NUMBER
231 (Rev 2, 08/24/2021)

TECHNICAL SERVICE BULLETIN

FRONT VIEW CAMERA REPLACEMENT FOR DTC C160449 & C160649

Front View Camera

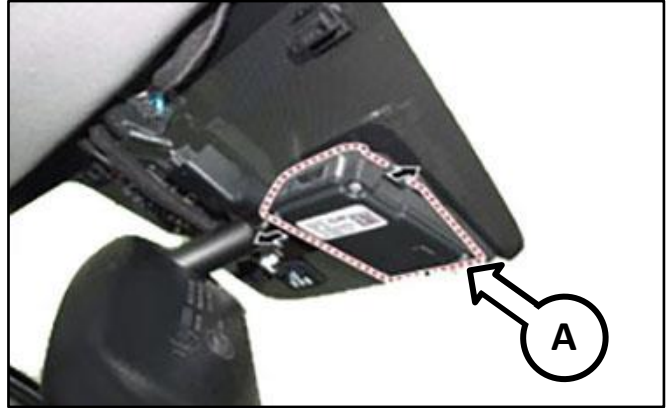
This bulletin provides information on the inspection and replacement of the front camera on some vehicles listed below. Due to an internal control chip concern inside the camera, the vehicle may exhibit a Forward Collision Avoidance Assist Warning Lamp (A) and/or Master Warning Lamp (B) with C160449 and/or C160649 codes. Certain systems may become temporarily disabled during occurrences: Smart Cruise Control (SCC), Lane Keep Assistance (LKA), Lane Departure Warning (LDW), Forward Collision-Avoidance Assist (FCA), Forward Collision Warning (FCW) and/or Driver Attention Warning (DAW). Follow the procedure outlined in this publication to diagnose and replace the front view camera assembly.

1. Remove and replace the Front View Camera (A) by referring to the “Body Electrical System → Front Camera System → Front View Camera Unit → Repair Procedures” chapter in the applicable Shop Manual on KGIS.

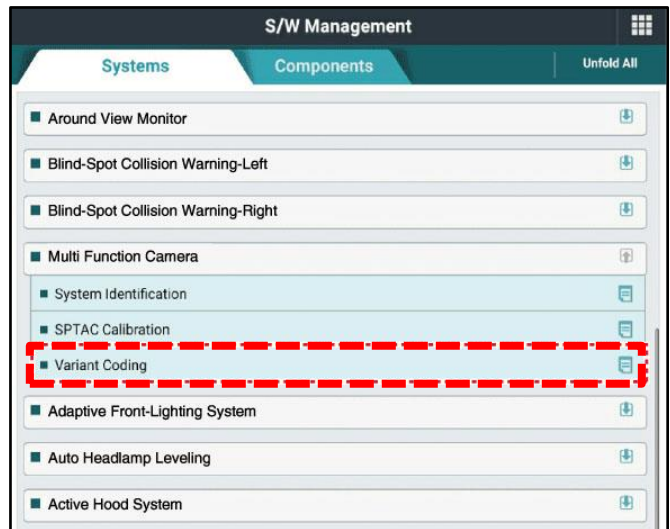
2. Perform the “Variant Coding” procedure by referring to the “Body Electrical System → Front Camera System → Repair Procedures” chapter in the applicable Shop Manual on KGIS.

After replacing the front camera with a new unit, the **Variant Coding** procedure must be performed.
